UNITED STATES PATENT AND TRADEMARK OFFICE

APPLICATION NO.	FILING DATE	FIRST NAMED INVENTOR	ATTORNEY DOCKET NO.	CONFIRMATION NO.
09/744,484	05/21/2001	Horst Grafe	HM-390PCT	5641

Office Action Summary	Application No. 09/744,484	Applicant(s) GRAFE ET AL.	
	Examiner Jason Daniel Prone	Art Unit 3724

DETAILED ACTION

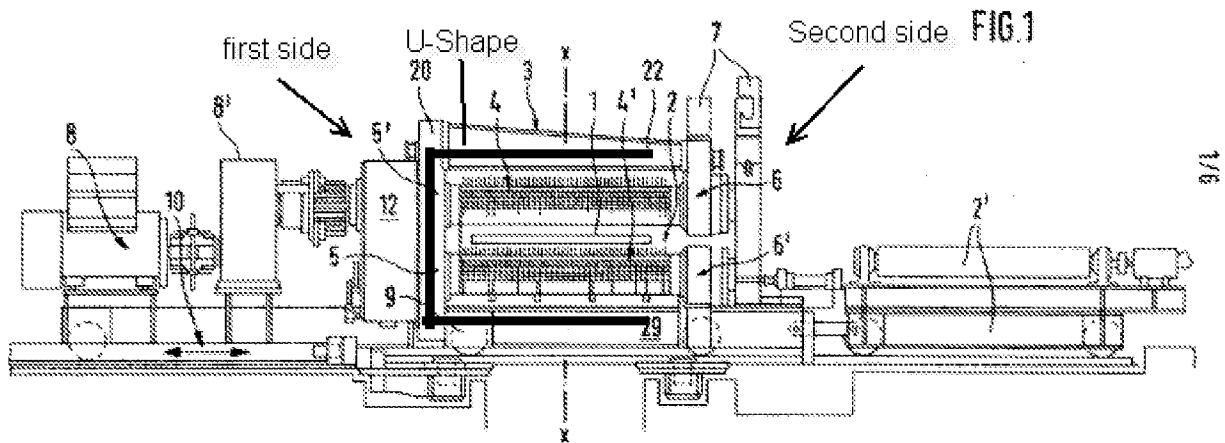
It is unclear what structure of the device (device being the tool as a whole) is the “shears” and what structure is the frame. Shears are labeled as item 3 but item 3 appears to be pointing at arm 22. Also, in the following paragraph the shears include additional structure not typically called shearing structure (i.e. drive apparatus). Using the typical definition of what one skilled in the art would consider shears to be, the shears should only be the cutting blade structure only. So the blade held by the blade holders would be what one skilled in the art would consider the shears. However, the description of Figure 1 in the specification calls the tool in the Figure “shears”. Is the tool as a whole to be called “shears”? If this is the case, the preamble should be “A shears device comprising”.

On lines 7-8, the phrase “shears arranged on the drive carriage, the shears including a drive apparatus and a U-shaped frame” is unclear. First, “the shears including a drive apparatus” is unclear. Using Figure 1, shears 3 are not remotely close to drive apparatus 8. How can item 8 be considered part of item 3? Next, “the shears 3 appear to be part of the U-shaped frame 20 not the other way around. Especially since shears 3 appears to be on arm 22 of the U-shaped frame. Finally, it would be the frame 20 not the shears 3 that is on the drive carriage 9 since shears 3 do not appear to be in communication with carriage 9.

On lines 8-9, the phrase “the frame having...a removable second side opposite the first side” is unclear. Using the Figure below, the U-shape frame appears to be items 20, 22, and 29. It is unclear what structure makes up the removable second side

of the frame. Basically it is clear what the second side of the frame would be but it is unclear what structure makes the second side removable.

On lines 8 and 10-11, the phrase “the frame having...an upper horizontal arm” is unclear. The frame is first disclosed as being U-shaped. Therefore the frame inherently discloses the structure allowing it to be U-shaped (vertical base and two horizontal arms). Now as claimed, the U-shaped frame has an upper horizontal arm in addition to the inherent U-shaped structure that would give the U-shaped frame 3 horizontal arms making the frame E-shaped.

On lines 11-14, the phrase “the shears further including holding element provided on the first side and the second side of the frame, and blade holders supported by the holding elements” is unclear. How can the holding elements be included as part of the shears structure when the holding elements are provided on the frame? The issue here appears to be what the base structure is. Using the Figure 1, it appears the frame incorporates two horizontal arms making the frame U-shaped; the arms have first

and second sides, holding elements on the first and second sides of the arms, blade holders supported by the holding elements and shears supported by the blade holders.
